**BUSINESS OF THE PLANNING AND ZONING COMMISSION
BONDURANT, IOWA
AGENDA STATEMENT**

TITLE: PZ-210923-22: Considering recommended approval of the JAS Concrete site plan at 701 23rd Street SW

The City is in receipt of a site plan for review by the Planning & Zoning Commission and City Council for the proposed JAS Concrete site at 701 23rd Street SW. This development site is comprised of 10 acres and is located within the Shiloh Rose Business Park Plat 2 Final Plat area. This development site is highlighted on the map below.

PROJECT NO.
5519-21A
SHEET
C4.1

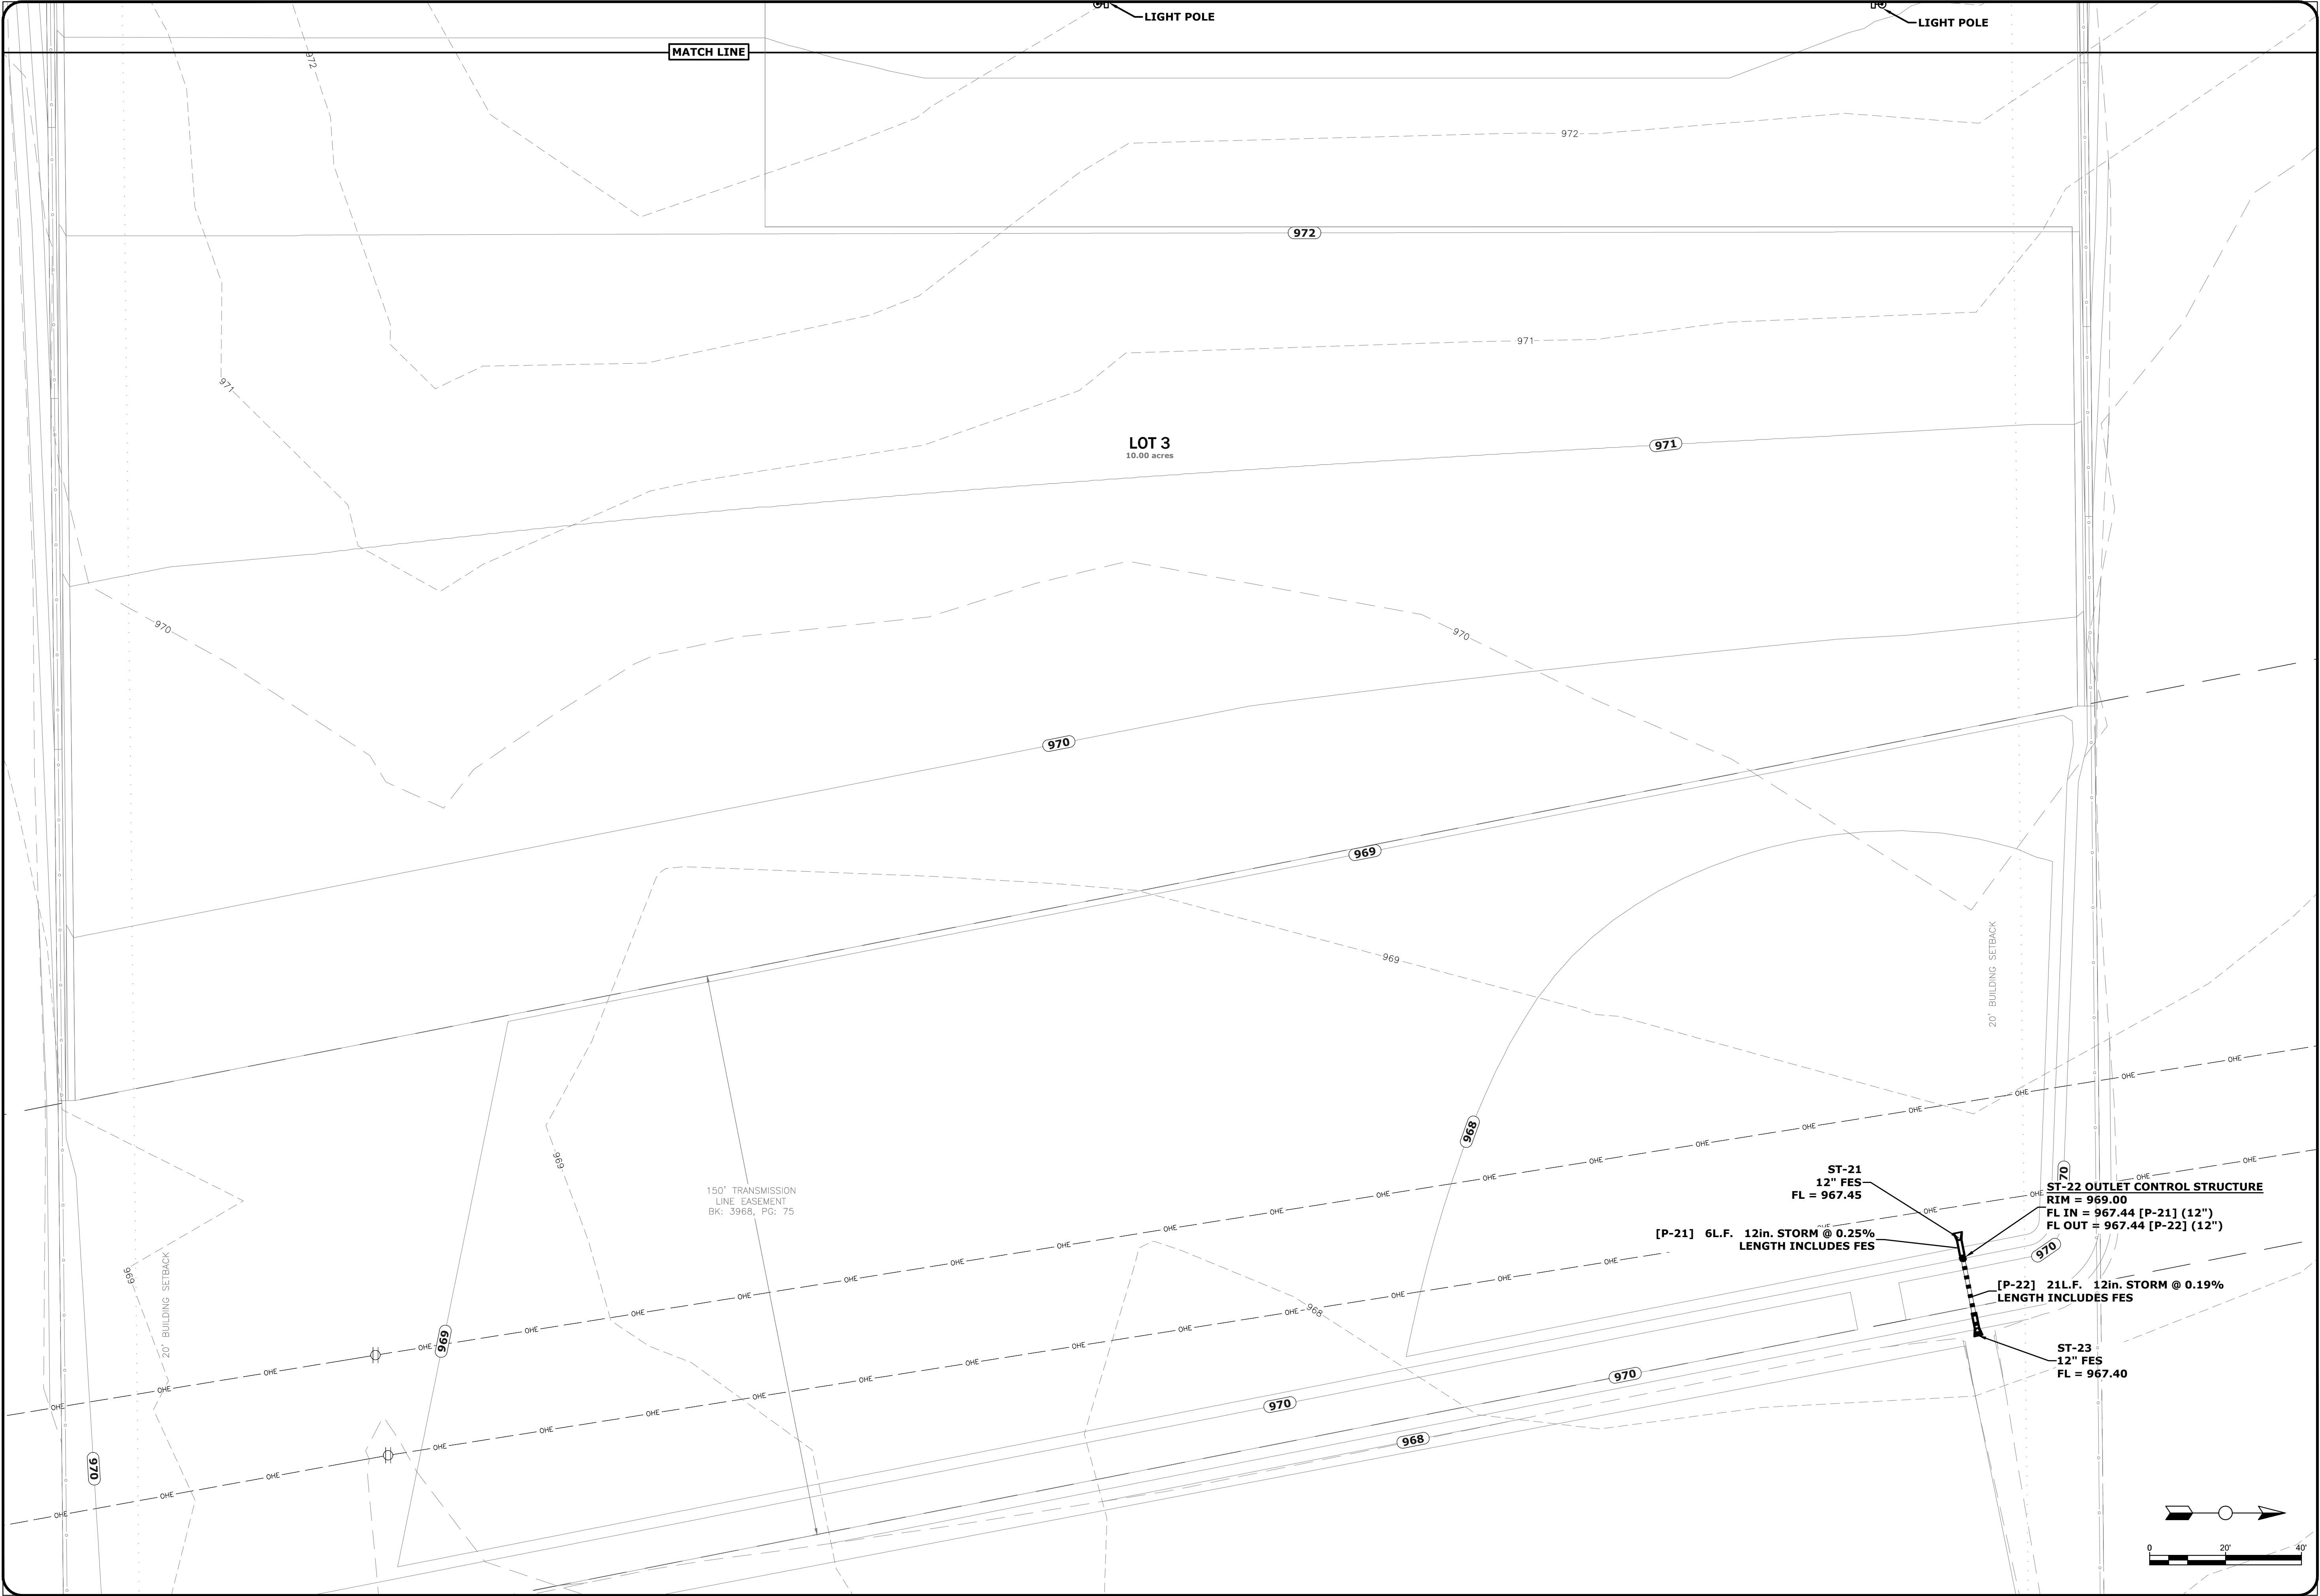
- The south detention basin will require written consent of MidAmerican Energy for the overhead transmission lines.
 - Pages C4.1 and C.42 contain the required utility plan. Notes on this:

- These pages show an extension of an 8" water main south to a hydrant located near the northwest corner of the building. The site plan must be updated to show the required hydrant coverage circles.

- The site plan shows both a 4" fire protection and a 2" domestic water service.
 - A 6" sanitary sewer service is extended south from the new sewer along the south side of 23rd Street to the building. The sanitary sewer service includes a sand/oil separator. The applicant will need to show documentation its sand/oil separator is in conformance with any requirements of the WRA relative to industrial facilities.

JAS CONCRETE OFFICE & WAREHOUSE COMPLEX
LOT 3 SHILOH ROSE BUSINESS PARK PLAT 2
BONDURANT, IOWA

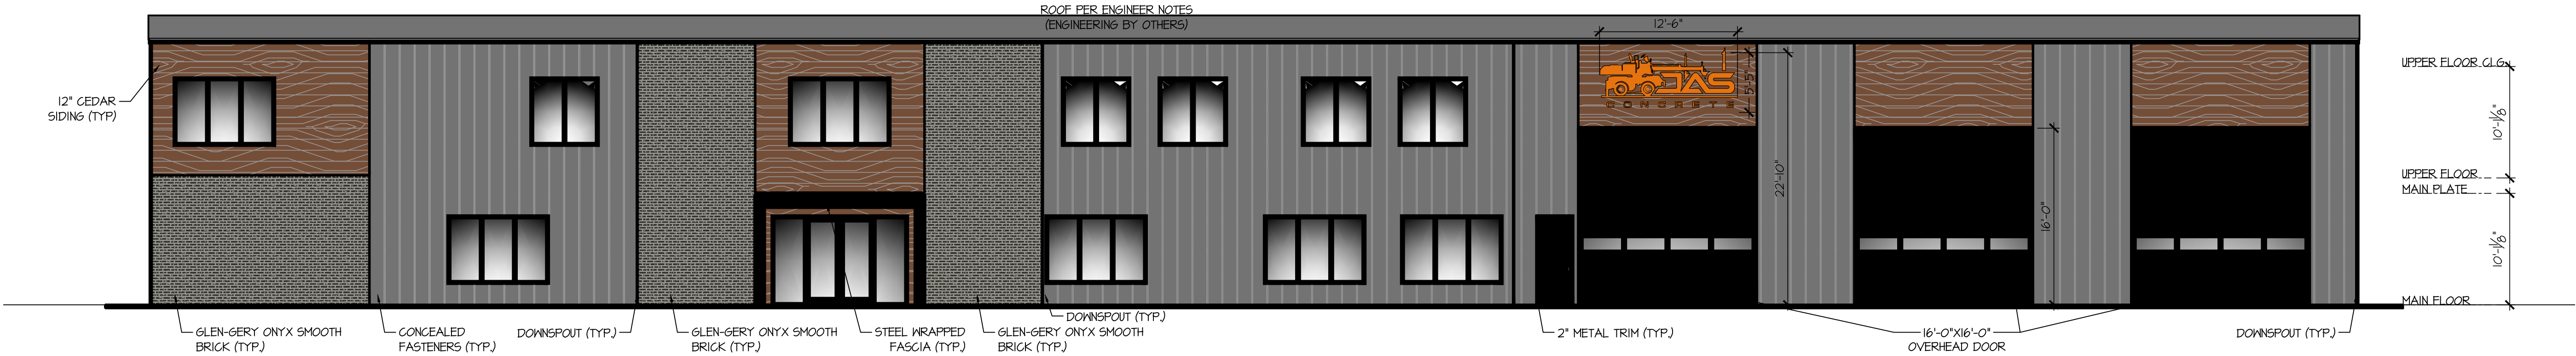
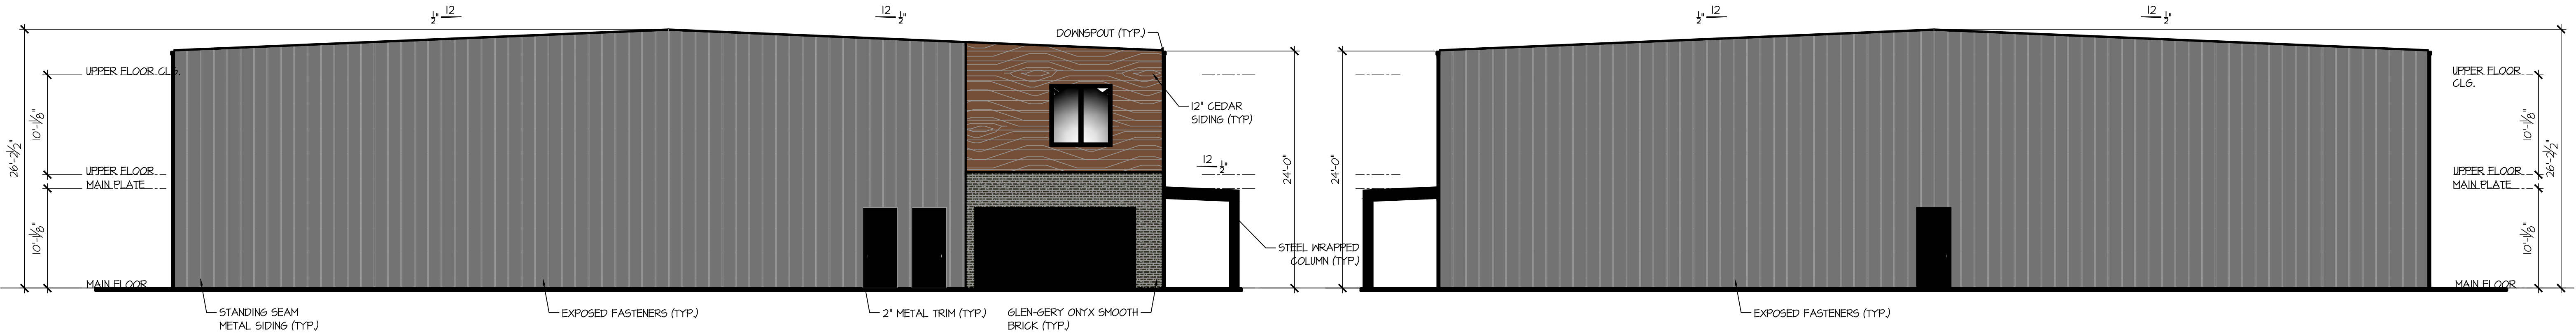
- Attached are the draft elevations that have been received. Notes on these elevations:
 - General requirements as regulated by Section 179.01.2.I.1 -
 - Section 179.01.2.I.2.a - buildings shall be designed such that there is adequate treatment or screening of negative aspects (loading areas, loading docks, HVAC mechanical units, non-residential overhead doors, etc.) from the public right-of-way and adjoining properties. *Site plan to be updated to show some*

- Section 179.01.2.I.1.a - buildings shall be designed to not expose loading docks or loading areas to the public unless screening is proposed. *Site plan to be updated to show some additional landscaping between the overhead doors facing north fahd the 23rd Street SW right-of-way so this requirement is met.*

- Section 179.01.2.I.1.b requires that roof mounted mechanical units shall be screened from view of public right-of-way. *The elevations do not show any roof mechanicals proposed.*

- The exterior building material of the front elevation shall be comprised of at least 50% glass, brick, concrete panels, textured concrete block, stone panels, or other similar material when after review by the Planning & Zoning Commission and City Council, the material when used as a primary element does not distract from the physical appearance of the building. *Feedback has been relayed by staff to the developer that the elevations will need to be updated to show this item as being met. Staff noted that for recent projects, architectural metal panels with concealed fasteners has been considered acceptable.*

- Industrial buildings shall incorporate facade modulation in all building elevations visible to the public right-of-way or other less intense uses. *The elevations show a variety of building materials on the front elevation to meet this requirement. The remaining elevations are not required to meet this, as they are not adjacent to a less intense use.*
